**TOWN OF CARMEL
PLANNING BOARD**

**PLANNING BOARD AGENDA
AUGUST 19, 2020 – 7:00 P.M.**

RE: Carmel Fire Department
94 Gleneida Avenue
Town of Carmel
TM# 44.14-1-24

Re: Carmel Fire Department Site Plan

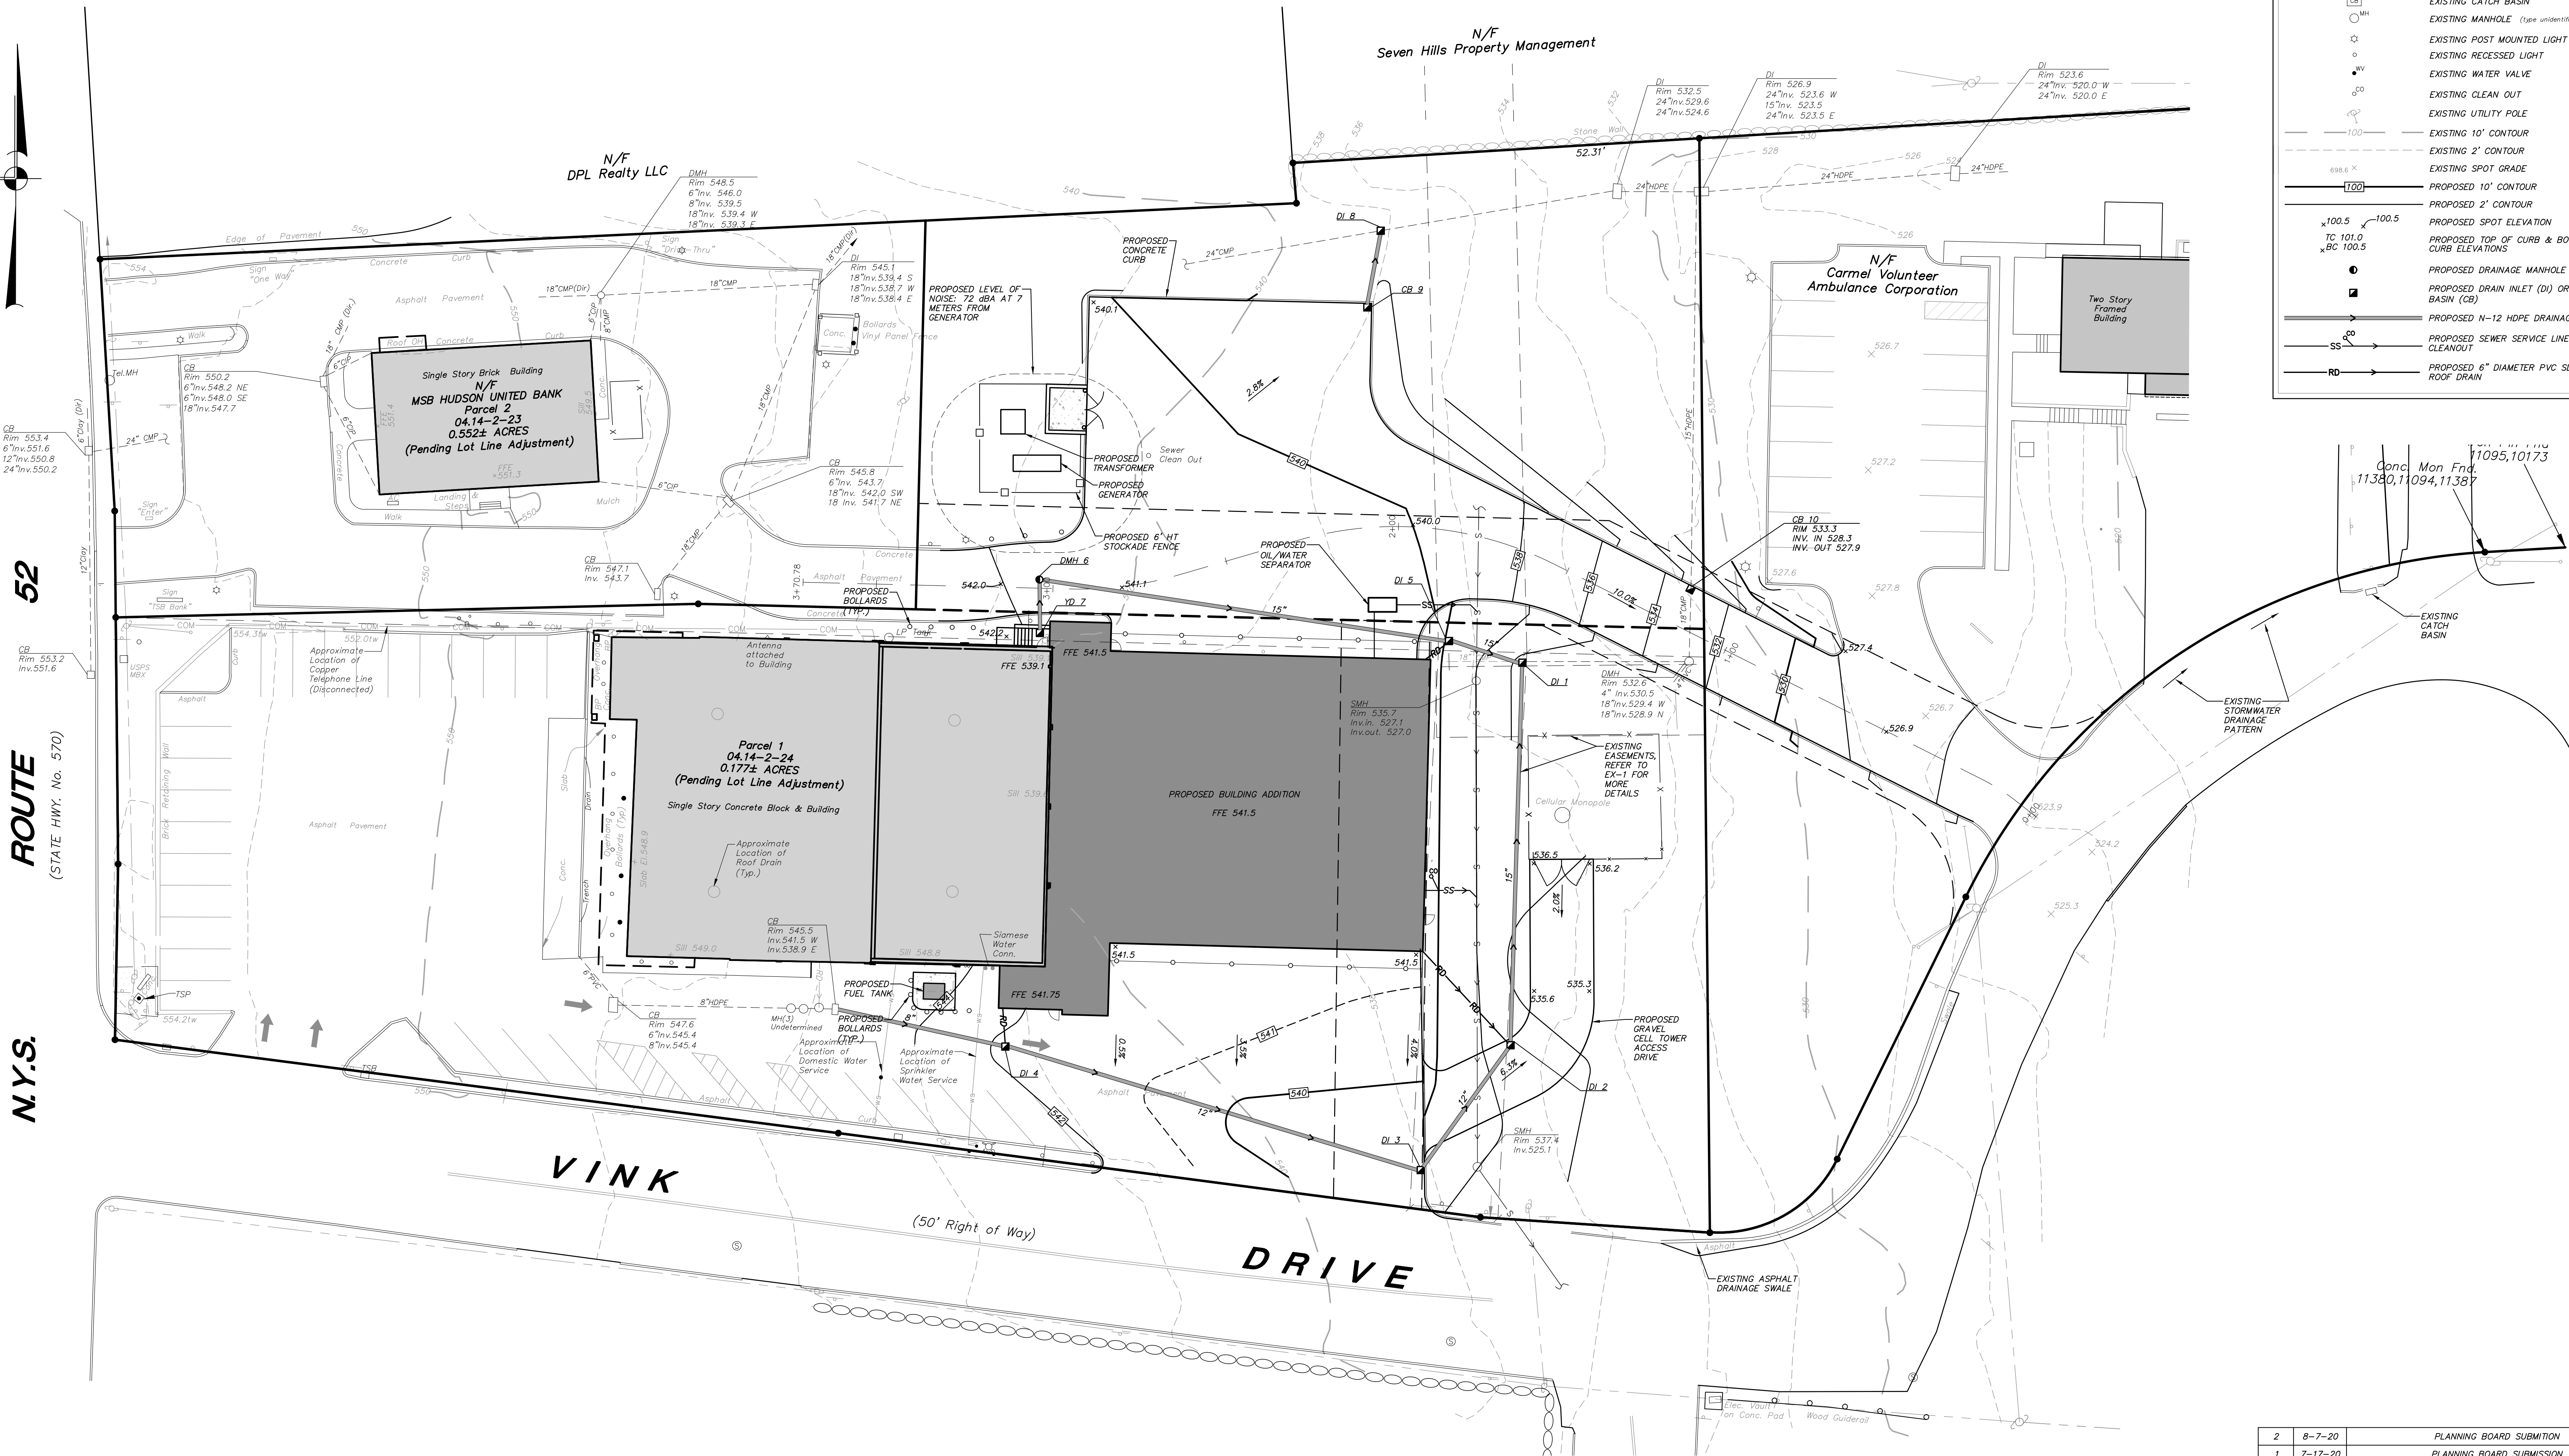
- 2) Additional information, as it relates to the size of the generator and transformer have been updated on Drawing SP-2. Additional screening has been added near the transformer and generator as shown on Drawing SP-2.
